Hillsborough County Florida

SM STAFF REPORT

SUBJECT:	PRS 20-1310	PLANNING AREA:	Riverview/Balm
REQUEST:	Minor Modification to an Approved PD	SECTOR	South
APPLICANT:	Balm Grove LLC		
Existing Zoning: PD 18-0304		Comp Plan Category: RP-2

Figure 3: Proposed Site Plan

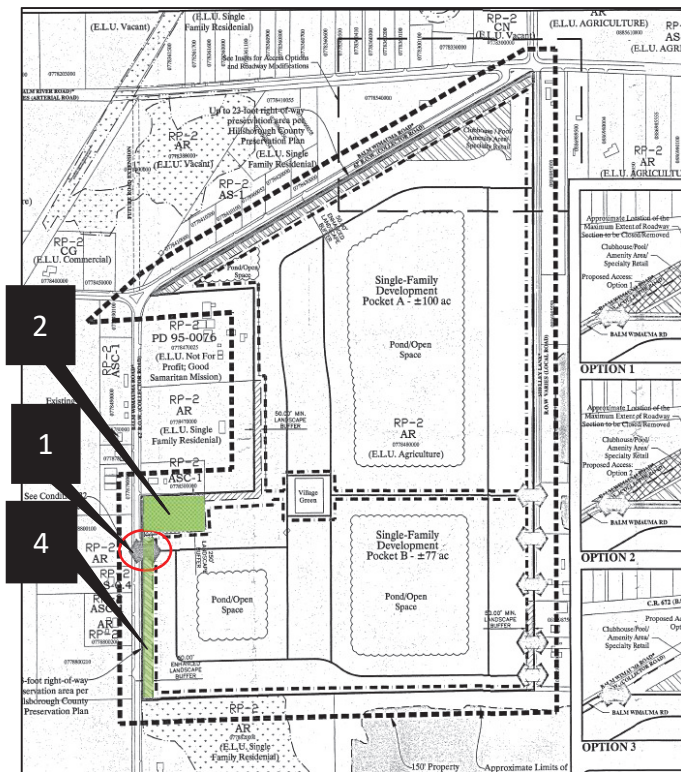
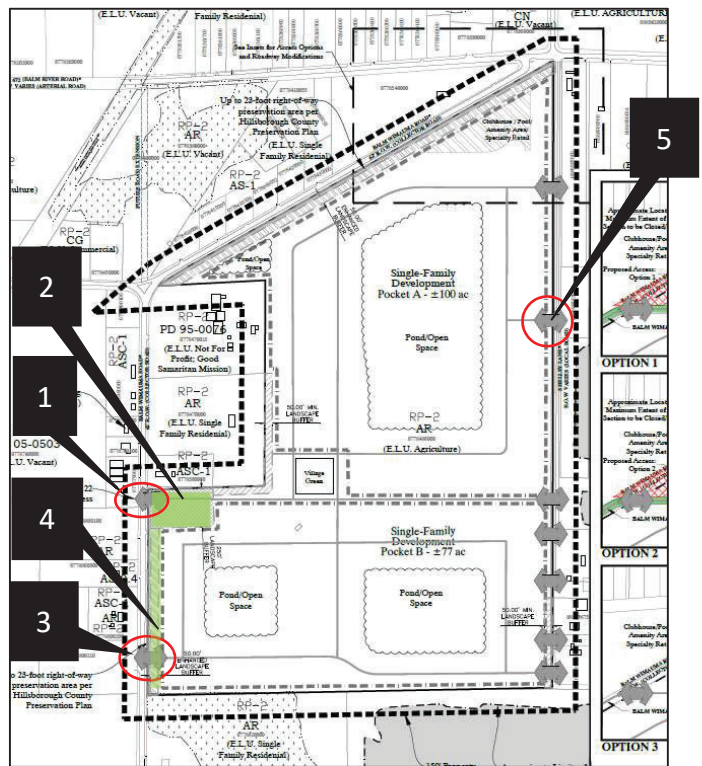
1. Relocate an access point and internal roadway northward along the western boundary, through a previous approved perimeter buffer. The subject access point and internal road in the northwest portion of the site (see #1 in Figure 2) was approved to be located outside of the 400 foot wide and 250 foot deep buffer positioned along the southern boundary of folio 77850.0000 (see #2 in Figure 2). Folio 77850.0000 at the time of the rezoning was not owned by the applicant. Since that time, folio 77850.0000 has been purchased by the applicant; however, it is not part of this PD. The new, proposed location (see #1 in Figure 3) is shown to be run horizontally through the buffer (see #2 in Figure 3).

The current moratorium restricts perimeter buffer reductions, unless the reduction is to provide for connectivity to adjacent property or rights-of-way. Staff concurs with the applicant's position that no buffer reduction is occurring due to the additional buffer area proposed. To accommodate the 50 foot wide internal road, the depth of the buffer will be increased to 300 feet, resulting in a 400 foot wide by 300 foot deep buffer (see Figure 4). The subject access point will continue to provide connectivity to the adjacent right of way. Furthermore, the residential building envelope remains to be located outside of the buffer.

Per the applicant, the relocation of this access point improves the internal circulation and provides an improved alignment with the eastern portion of the roadway which connects to Shelley Lane, allowing for a more direct travel route between the two roadways.

The applicant has requested an additional access point to serve the project and Pocket B (see #3 on Figure 3). This new access point will provide direct access to the north/south segment of Balm Wimauma Road for the southern project area (Pocket B). Under the original rezoning, a reduced buffer of 50 feet in width was approved in this area (see #4 on Figures 2 and 3).

The current moratorium restricts perimeter buffer reductions, unless the reduction is to provide for connectivity to adjacent property or rights-of-way. Per the applicant, the additional access point to the adjacent right-of-way further advances the connectivity of the project to adjacent roadways, while also providing more travel options for project residents. The residential building envelope remains to be located outside of the buffer.

The applicant has requested an additional access point to provide better connectivity and circulation (see #5 in Figure 3) for the project. This proposed access along Shelley Lane will provide an additional access point for the northern PD area (Pocket A). Under the original rezoning, a waiver to the required 250 foot buffer was approved in this location.

Figure 5: Proposed Site Plan

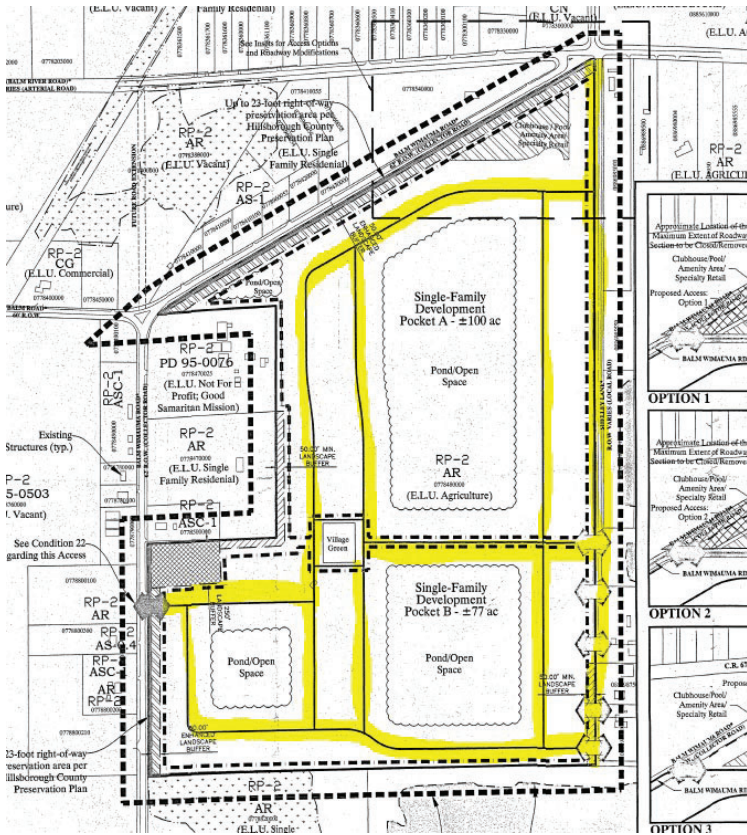
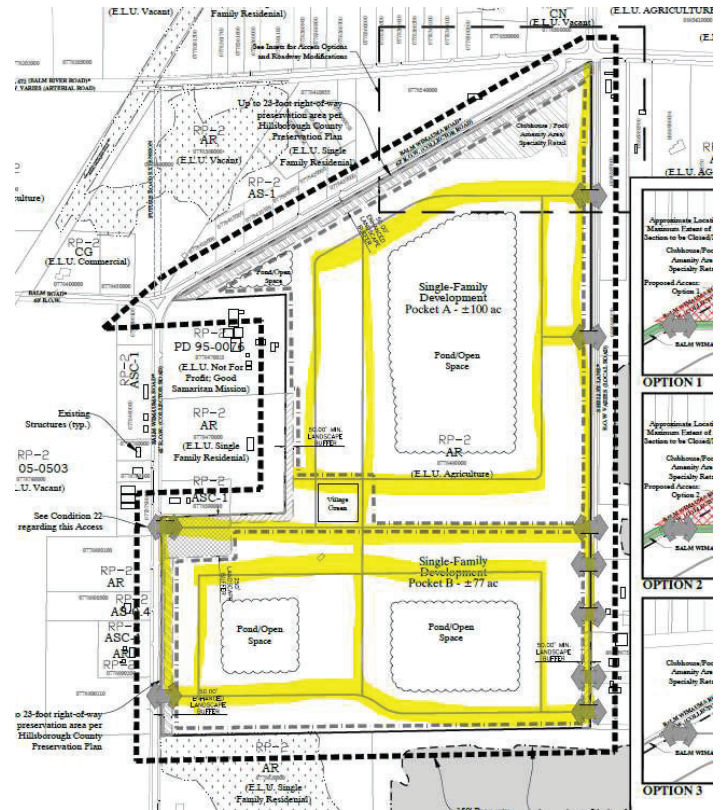
The project's internal circulation network is proposed to be revised from the 2018 layout (see Figures 4 and 5). The original road network serves Pockets A and B with access points along the west (Balm Wimauma Road) and east (Shelley Lane). Internal connection between Pockets A and B are available via three north/south internal roadways, Balm Wimauma Road and Shelley Lane (see Figure 4). Under the revised layout, one north/south internal roadway will extend to Pocket B to serve as an internal connection between the two areas (see Figure 5). Perimeter access opportunities remain. Pocket B will continue to be situated around two pond/open space areas.

Figure 6: Approved Perimeter Buffer Waivers

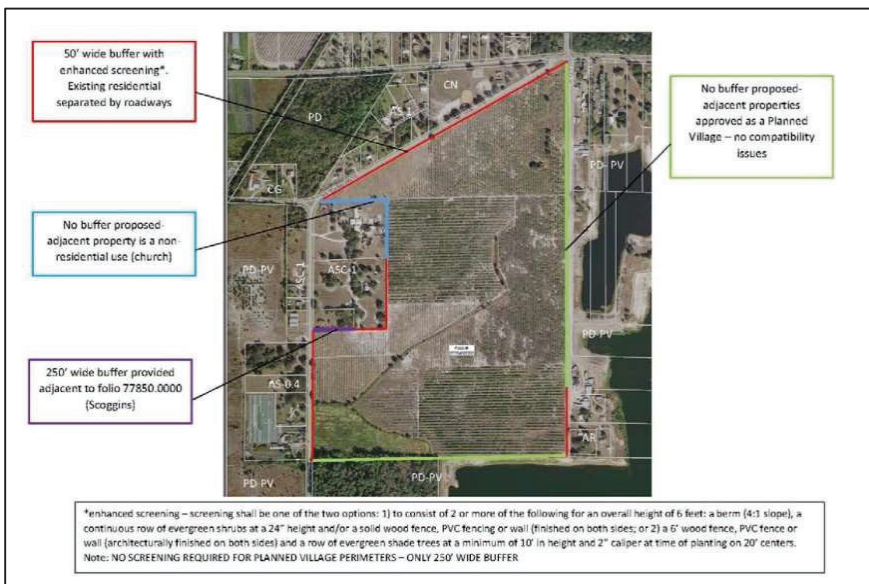
No PD variations are proposed under this minor modification. Under PD 18-0304, the Balm Grove area was approved with a reduction to the 250 foot perimeter buffer around 70% of the site requirement (see Figure 6).

RHODINE BORROW PIT & THE GROVE PARCEL
GREENPONT COMMUNITIES
GENERAL SITE DEVELOPMENT PLAN

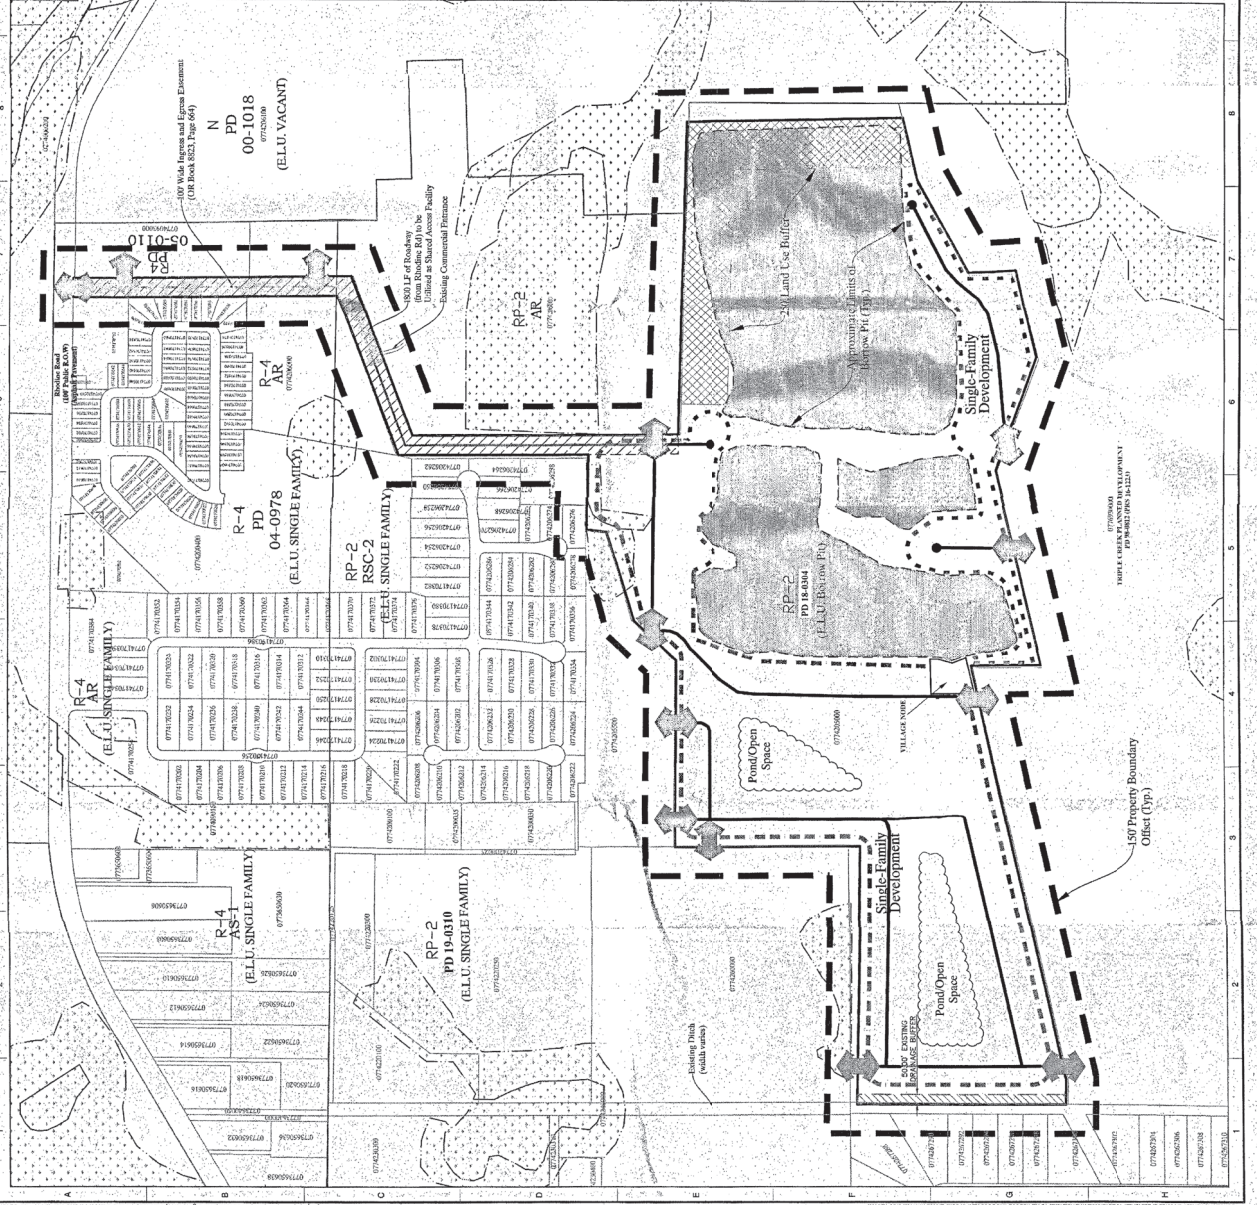
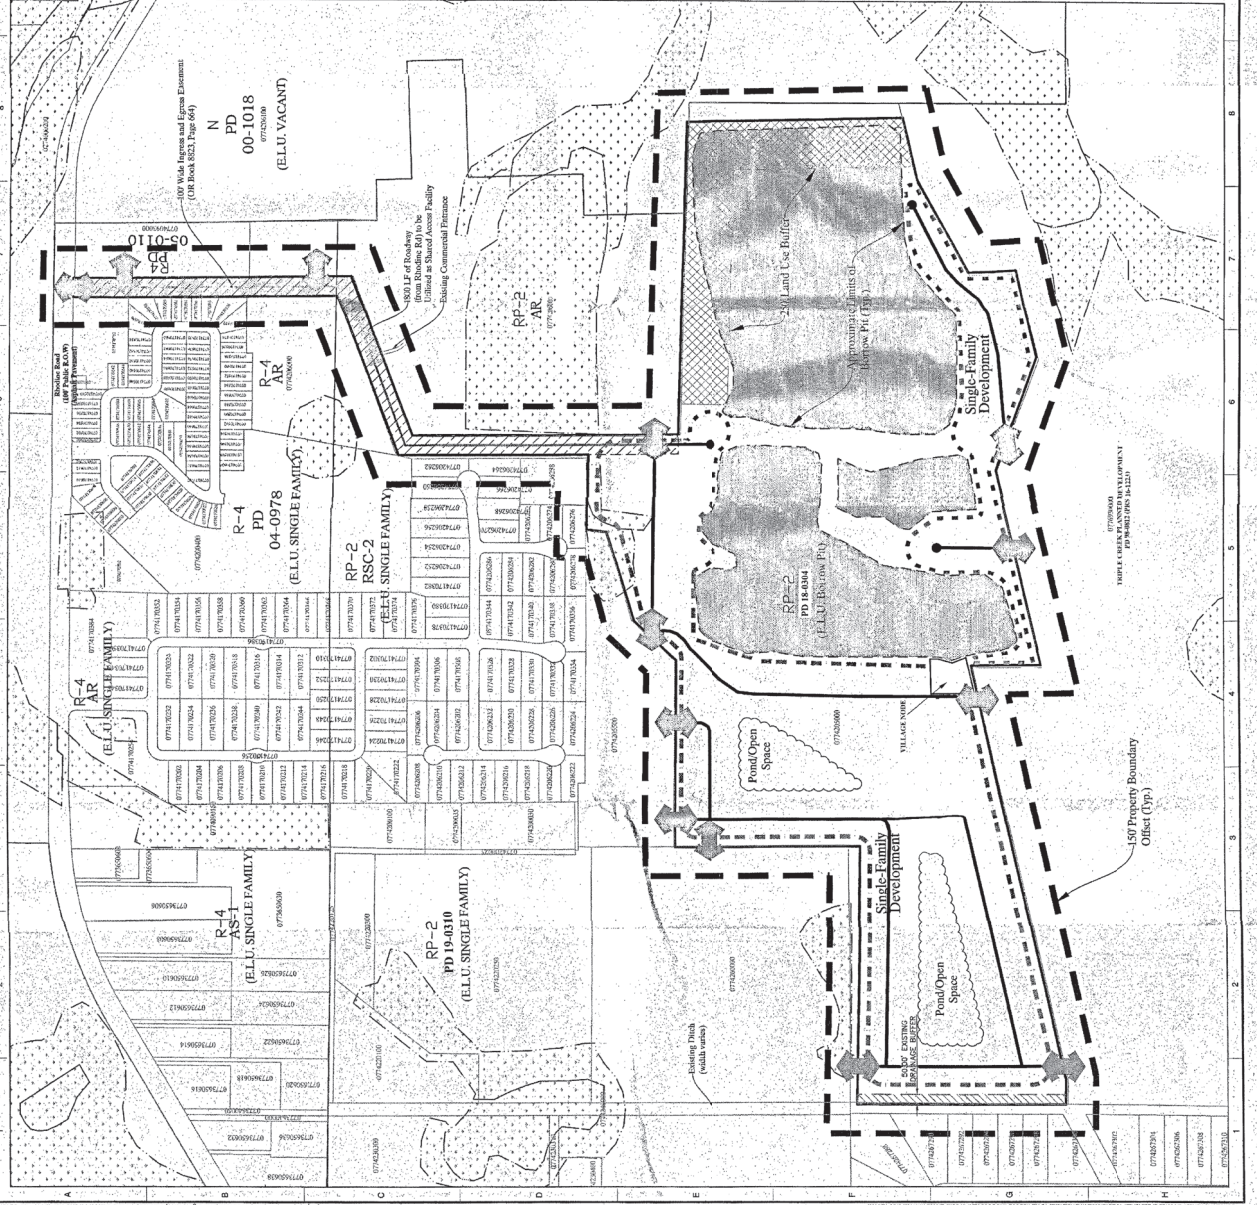
1. All plan sheets to be submitted for certification.
2. On “The Grove” sheet, reference to Condition #22 on the plan for the northern western access point to be corrected to Condition #27.
3. The northwest buffer depth to be corrected to 300 feet.

[Transportation Review Section staff is proposing to renumber condition 22 to 27. There is a notation on the existing site plan which should have referred to 27 instead of 22. Staff is proposing to fix the issue by renumbering the conditions.]

[Transportation Review Section staff is proposing to renumber condition 27 to 22. There is a notation on the existing site plan which should have referred to 27 instead of 22. Staff is proposing to fix the issue by renumbering the conditions. Staff is also modifying the condition to reflect the addition of a second access connection to in the vicinity of the original connection.]

~~27.~~ 22. Notwithstanding anything shown on the PD site plan to the contrary, the developer shall relocate the southernmost two access connections on Balm Wimauma Rd. such ~~that it is~~ they are located a minimum of 330 feet from the nearest adjacent access connections. ~~However, the access point shall not be located any further than 600 feet from the southern boundary of folio 77850.0000.~~ Alternatively, the developer shall obtain a Section 6.04.02.B. administrative variance from the Section 6.04.07. access spacing requirements.

Modified Access Connection

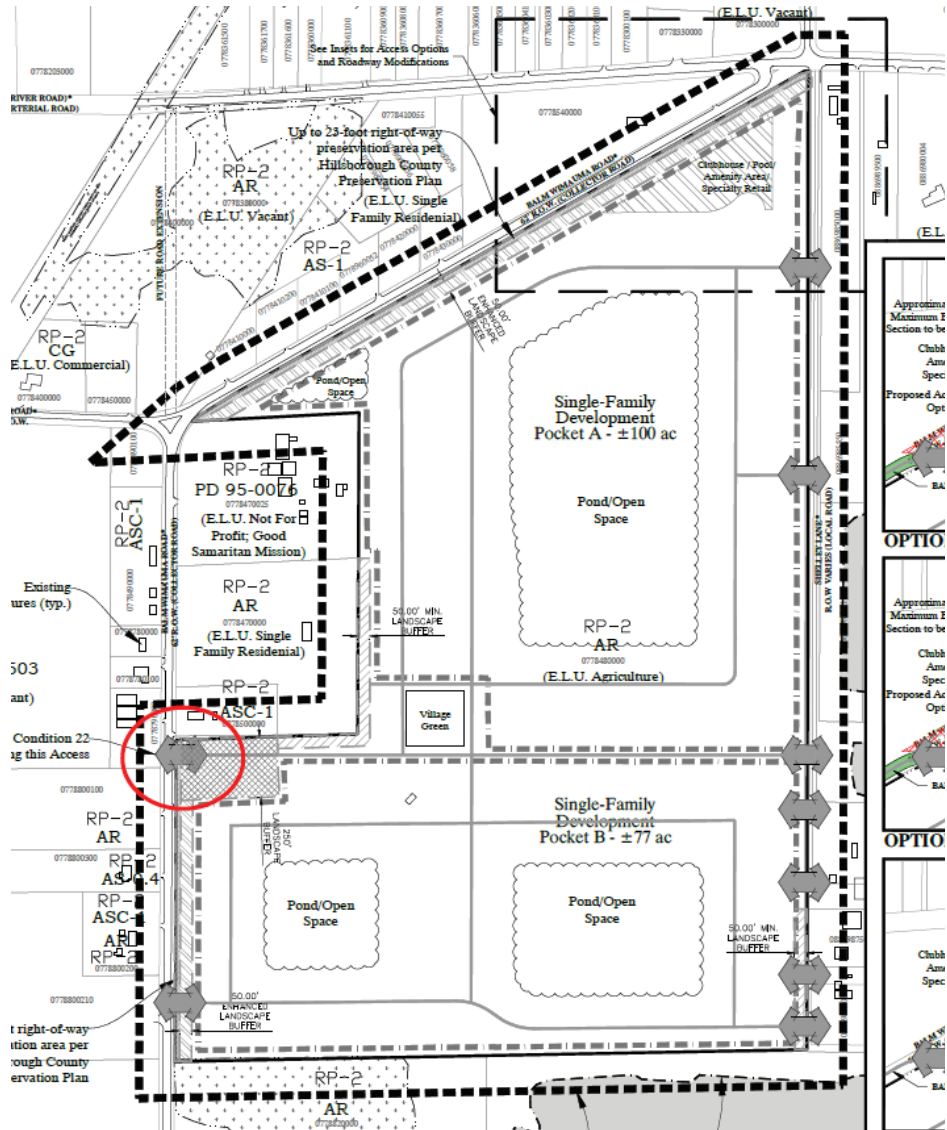
The applicant is proposing to shift the second most southern driveway connection to the north of its previous location (as indicated by the red circle in the image shown at right). The applicant indicates that they have acquired the property to the north of this access (folio 077850.0000) which now provides them additional flexibility with respect to this access. It should be noted that the adjacent folio is not included within the subject PD. As such, staff cannot place a condition requiring its closure with the subject PD. Staff is not objecting to this change, given the condition requiring the access be located a minimum of 330 feet from other access points is still in effect (previously condition number 22, now renumber to condition 27 as further explained above). This condition will ensure that access standards are met as detailed in the condition or the access otherwise relocated.
